CHRISTEN INDUSTRIES, INC.
1048 SANTA ANA VALLEY ROAD
HOLLISTER, CALIFORNIA 95023
TELEPHONE: (408) 637-7405

Send To: 904 FUSELAGE KIT

Subject: INSPECTION OF EAGLE II
AIRCRAFT 904 FUSELAGE
STRUCTURE FOR PRESENCE
OF TUBULAR ELEMENTS

1 EA Engineering Sketch X-90117

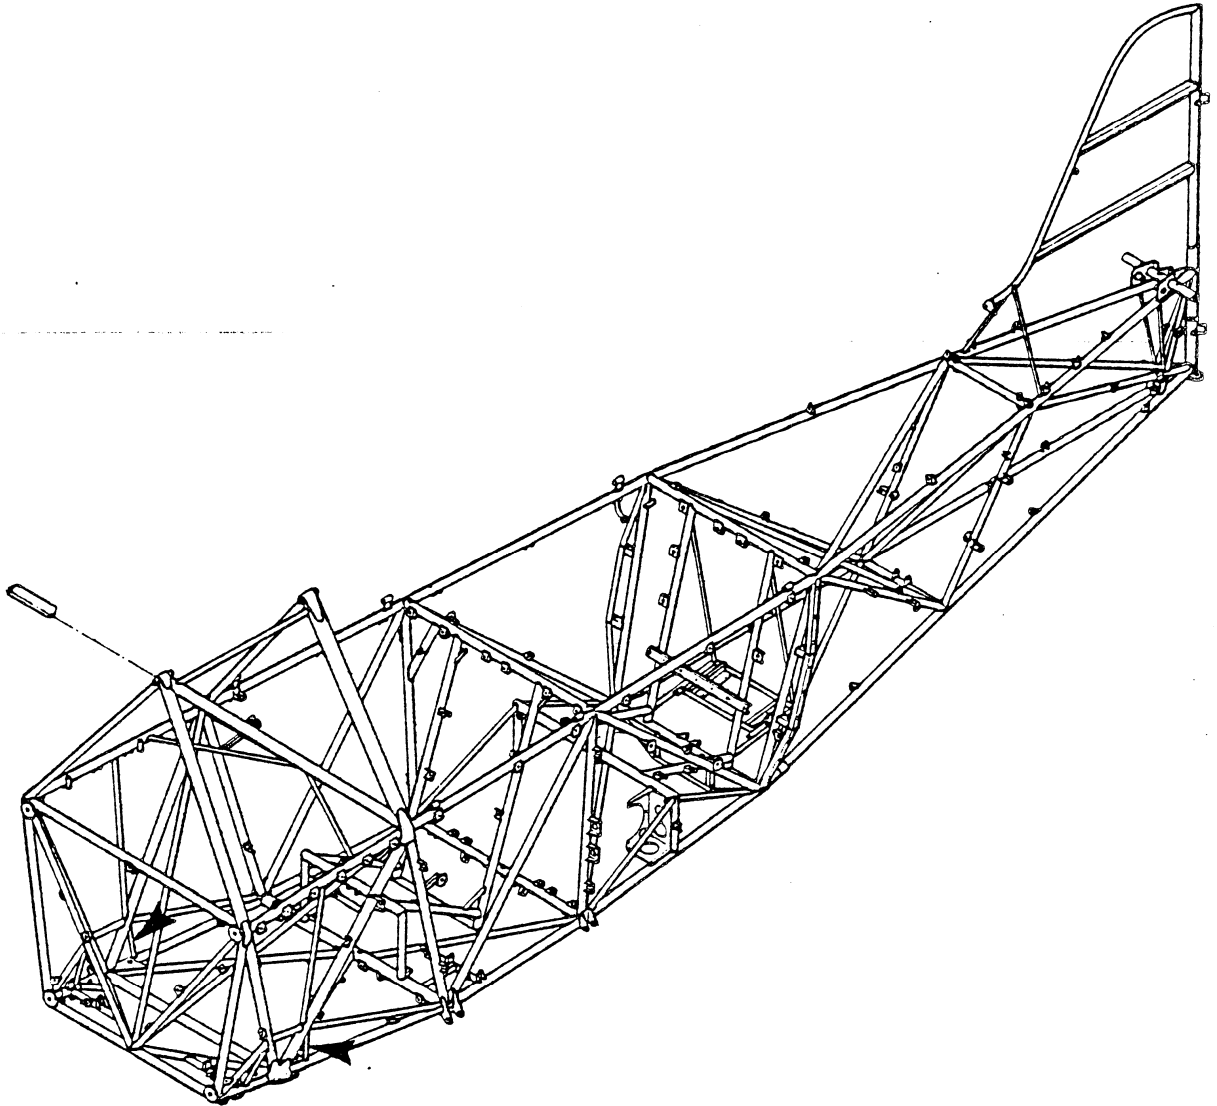
Recent factory inspection activities indicate that there is a possibility that your 904 fuselage structure may have been manufactured with two small tubular elements omitted from the landing gear attach area.

Please inspect your fuselage structure in accordance with the attached Engineering Sketch 90117 to verify the presence of the two 3/8 diameter tubes which are located immediately aft of the forward wing attach fittings as indicated by the arrows.

VERIFY THAT THE REINFORCEMENT TUBES
 MARKED WITH AN ARROW HEAD ARE ATTACHED

If the tubes are not present on your fuselage structure, please telephone the Christen factory collect to arrange for corrective action.
